Westlake + John

Design Review Board
201 WESTLAKE AVENUE | SEATTLE, WASHINGTON

MACFARLANE PARTNERS / ANKROM MOISAN ARCHITECTS, INC.
07.31.2013

Design Review Board Comments from EDG

View of North Facade from Westlake

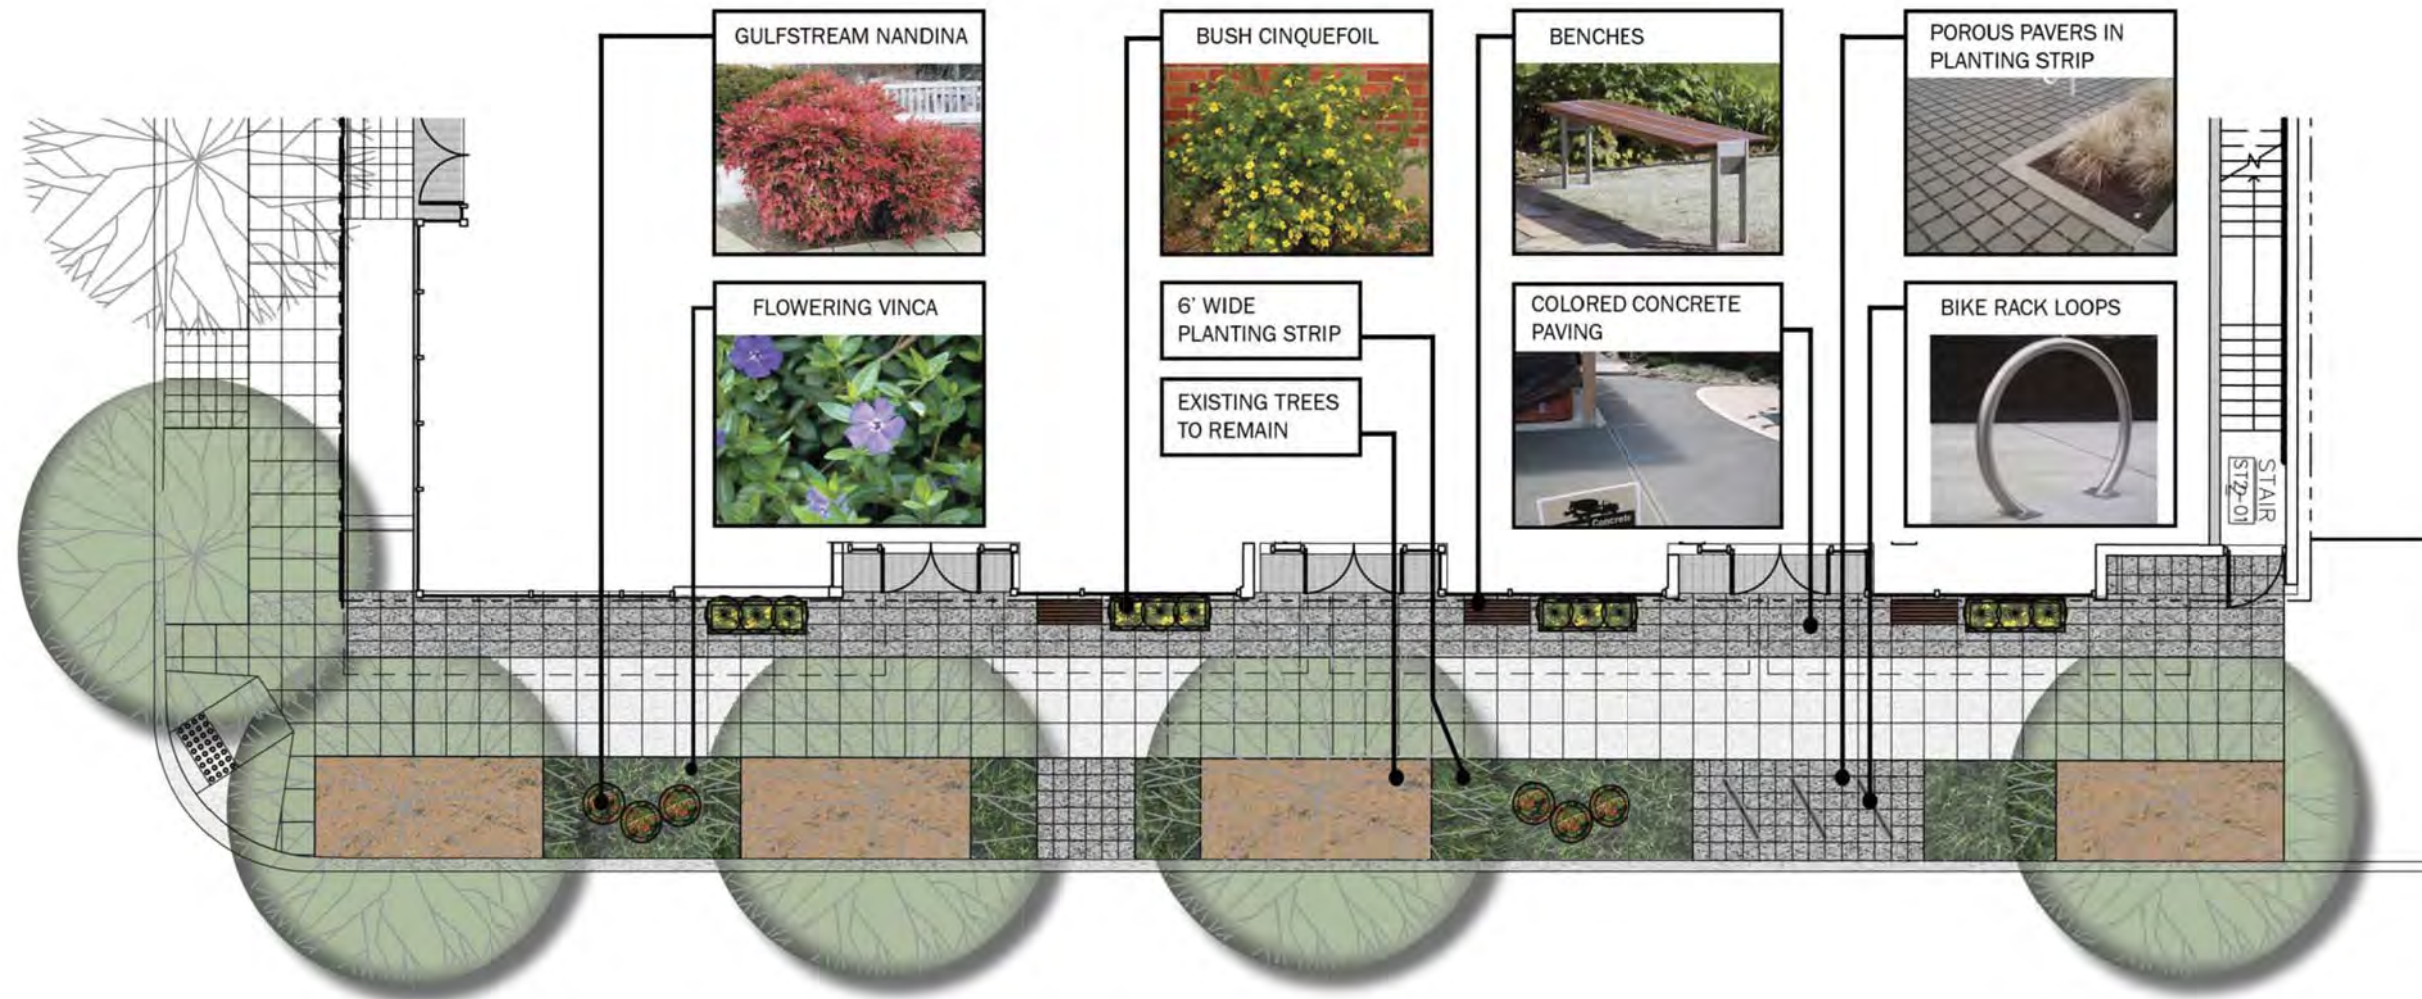
“... the opportunity to provide something truly creative on the north facade that would respond to the concerns expressed by the neighbor...”

“The treatment and appointments of the common amenity space at the NW corner, how it related functionally to the whole building, was vital for its success...”

“Where blank walls are unavoidable, they should receive design treatment to increase pedestrian comfort and interest.”

STREETSCAPE PLAN— WESTLAKE AVE. NORTH

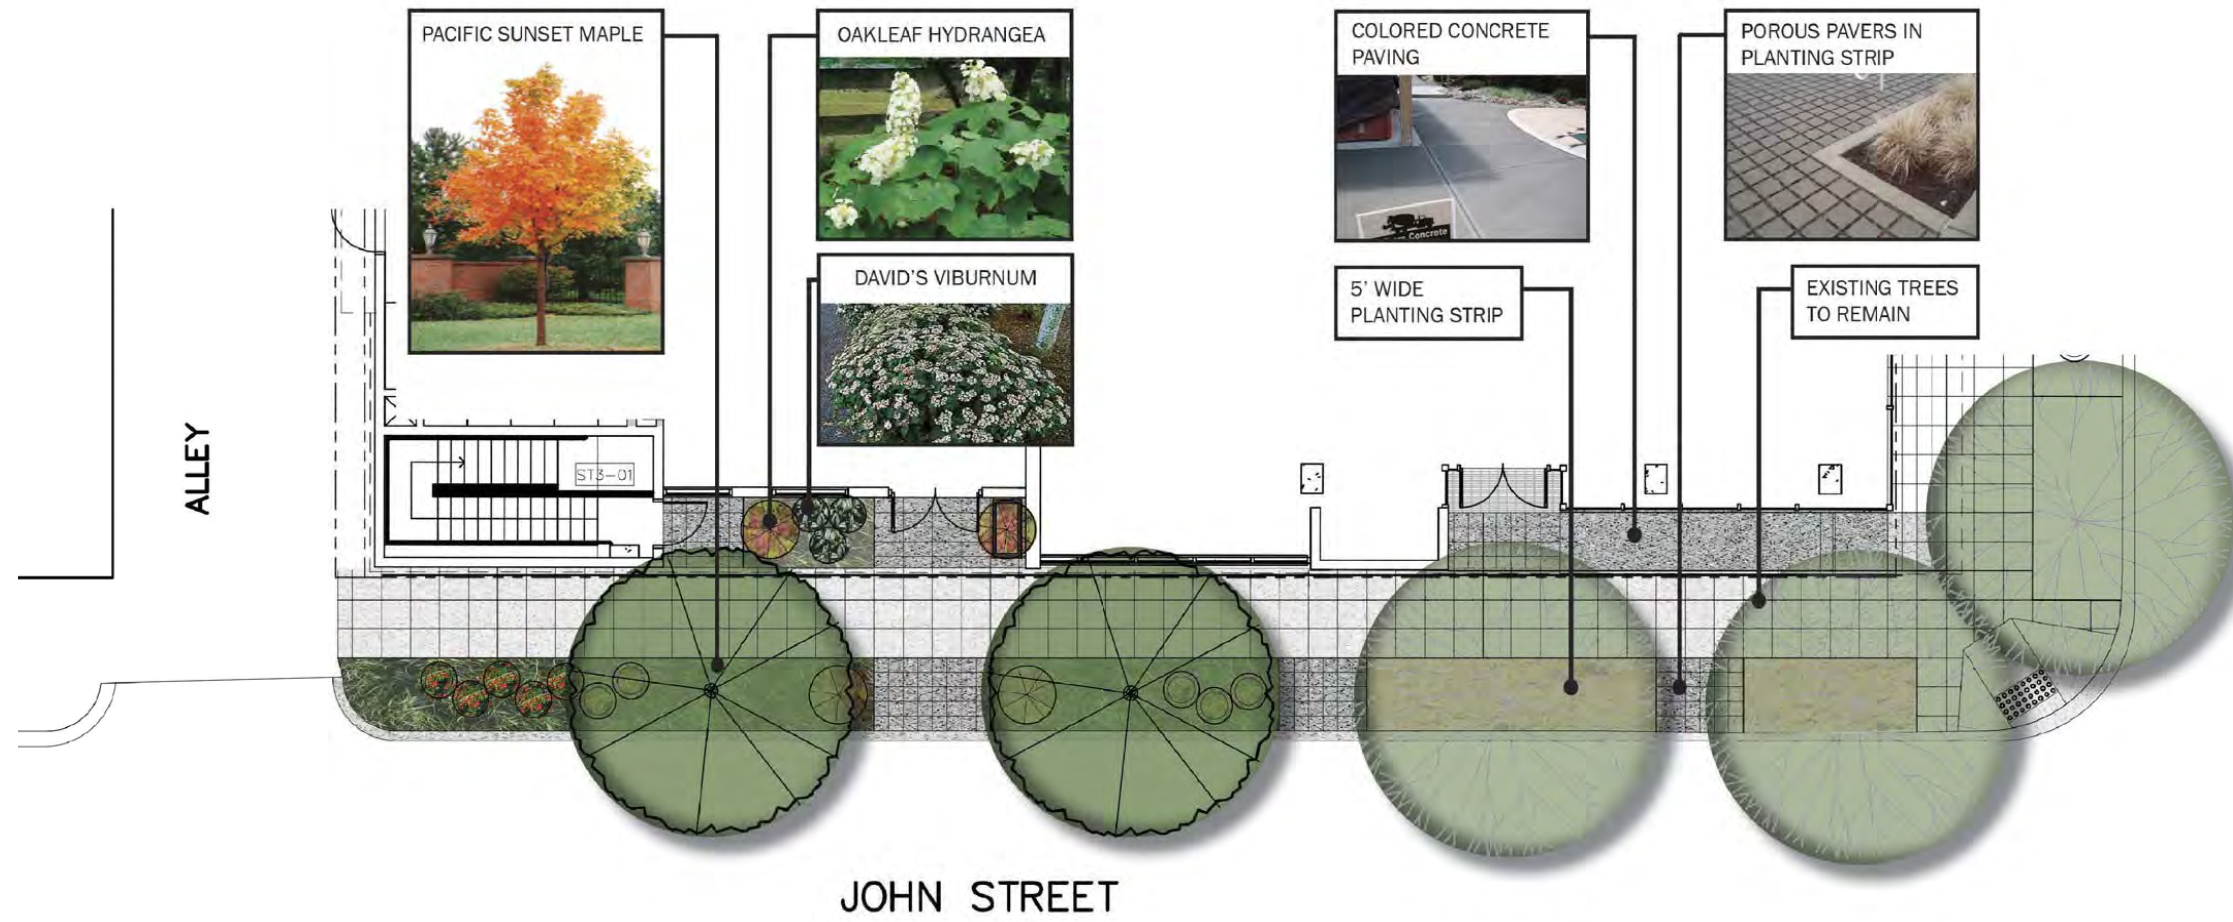
“There appears to be plenty of opportunity for landscaping not only at the street level but as part of the amenity spaces above ground.”

“...the presence of the adjacent street trees and their integration within an overall landscape design posed special challenges...”

Enlarged Plan - Parking Garage Entry

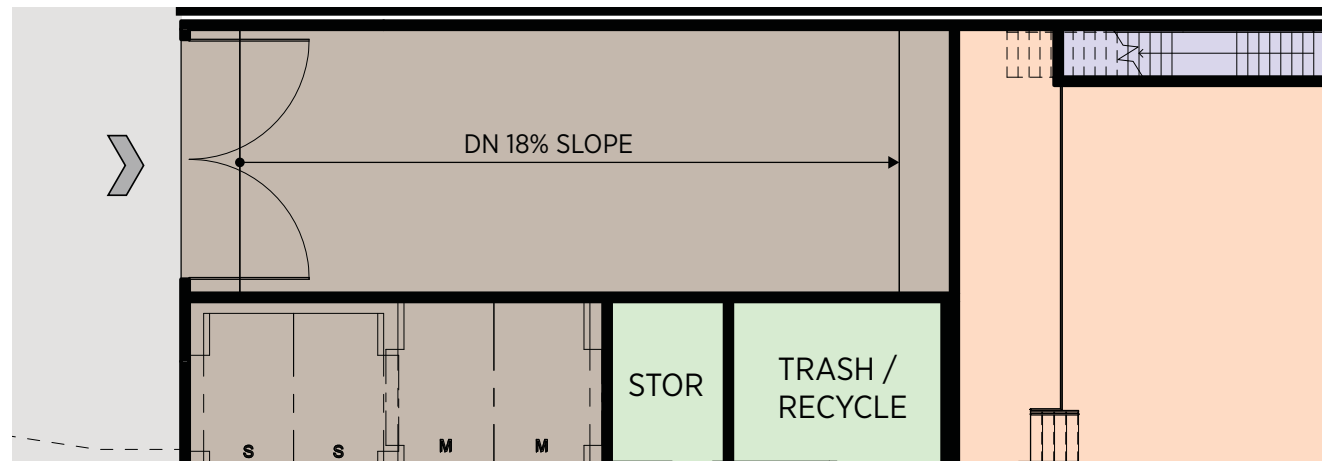
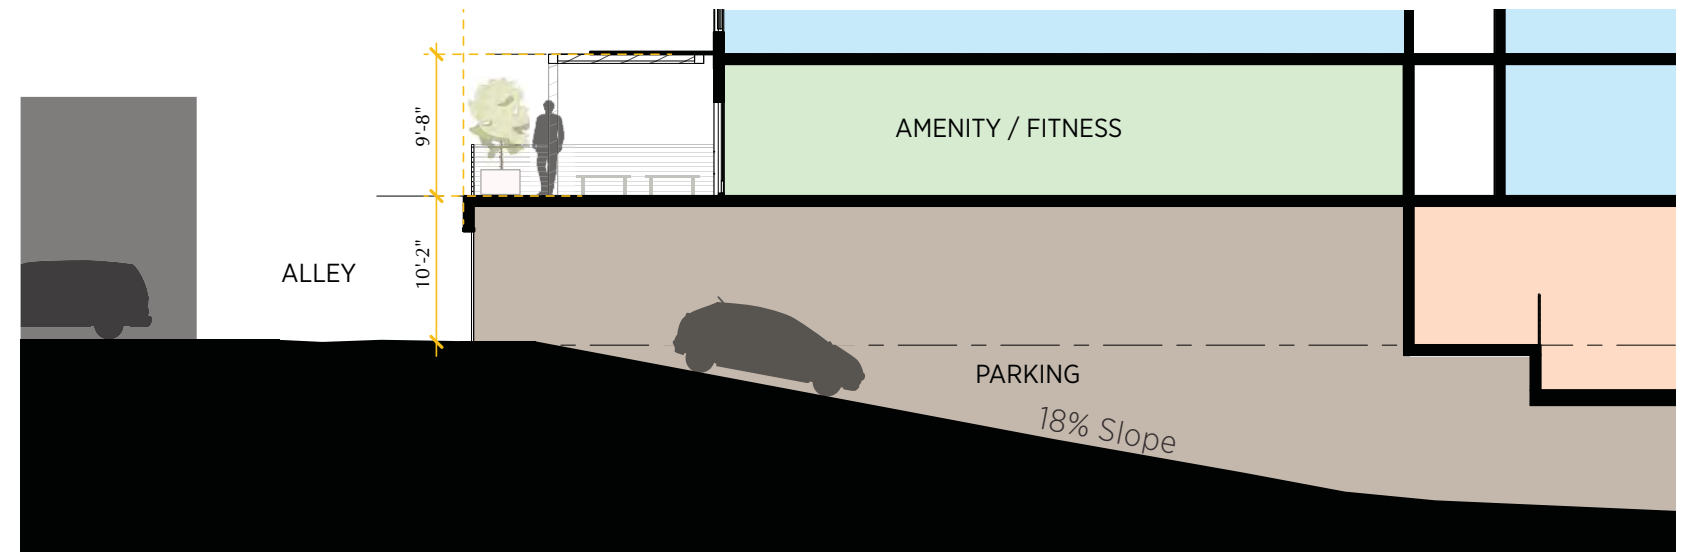
Land Use Code Section	Code Description	Potential Departure	Comments
23.54.030.E.4	Aisle slope shall not exceed 17 percent provided that the Director may permit a greater slope if the criteria in subsection D.4.a, D.4.b, and D.4.c of this Section 23.54.030 are met.	Drive aisle slope of 18% exceeds max	In order to limit parking to one level, and maintain clearance below the retail which requires a 13'-floor-to-floor height, the ramp to bring vehicles from the alley to level P-1 must become 1% steeper than the requirement by code.
